CLARK COUNTY, NEVADA BID NO. 603579-15 DURANGO DRIVE, TROPICANA AVENUE TO DESERT INN ROAD

March 13, 2015

ADDENDUM NO. 2

REMOVE AND REPLACE

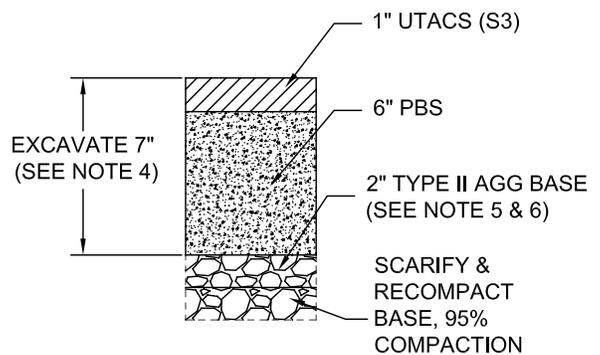
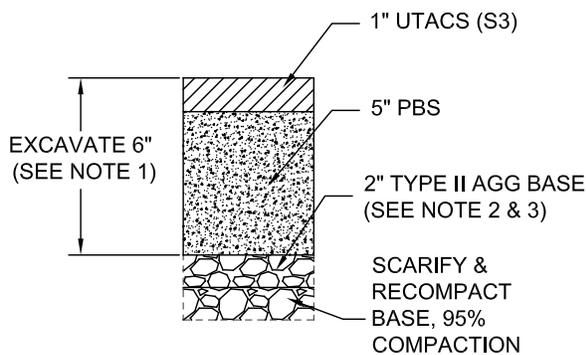
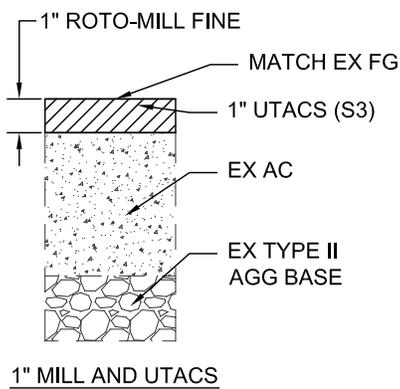
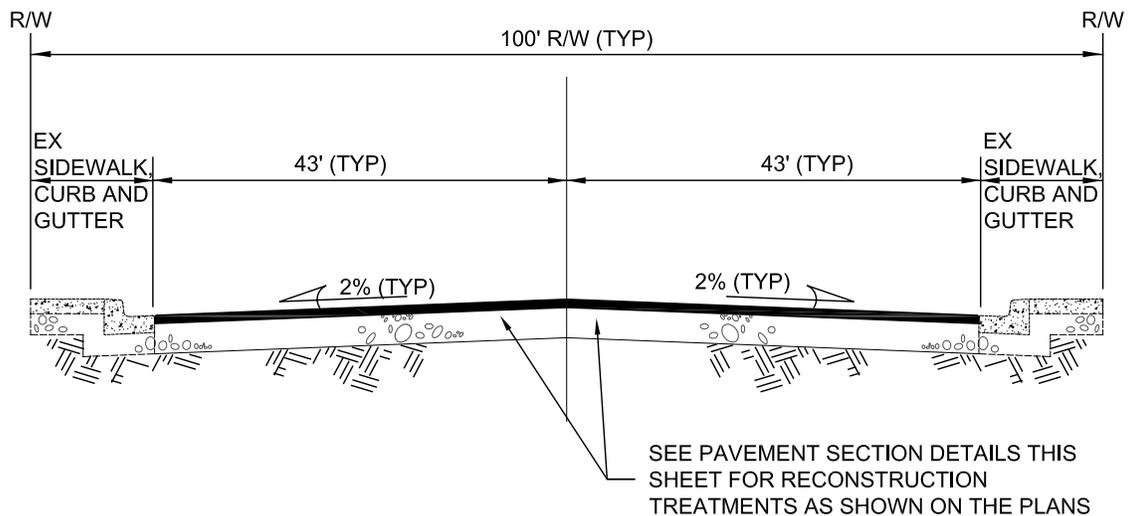
1. EXCAVATE ONLY 6-INCHES. ALL AREAS THAT NEED ADDITIONAL REMOVAL SHALL REQUIRE FIELD APPROVAL FROM CCPW DESIGN ENGINEER OF RECORD BEFORE ADDITIONAL EXCAVATION OPERATIONS ARE PERFORMED.
2. AFTER APPROVAL FROM CCPW DESIGN ENGINEER, IN AREAS WHERE EXISTING PBS IS GREATER THAN 6", REMOVE MATERIAL TO AN 8" DEPTH, FILL 2" WITH TYPE II AGG.
3. EXACT LOCATIONS WHERE EXCAVATION EXCEEDS 6-INCHES SHALL BE DOCUMENTED AND QUANTIFIED.
4. EXCAVATE ONLY 7-INCHES. ALL AREAS THAT NEED ADDITIONAL REMOVAL SHALL REQUIRE FIELD APPROVAL FROM CCPW DESIGN ENGINEER OF RECORD BEFORE ADDITIONAL EXCAVATION OPERATIONS ARE PERFORMED.
5. AFTER APPROVAL FROM CCPW DESIGN ENGINEER, IN AREAS WHERE EXISTING PBS IS GREATER THAN 7", REMOVE MATERIAL TO AN 9" DEPTH, FILL 2" WITH TYPE II AGG.
6. EXACT LOCATIONS WHERE EXCAVATION EXCEEDS 7-INCHES SHALL BE DOCUMENTED AND QUANTIFIED.
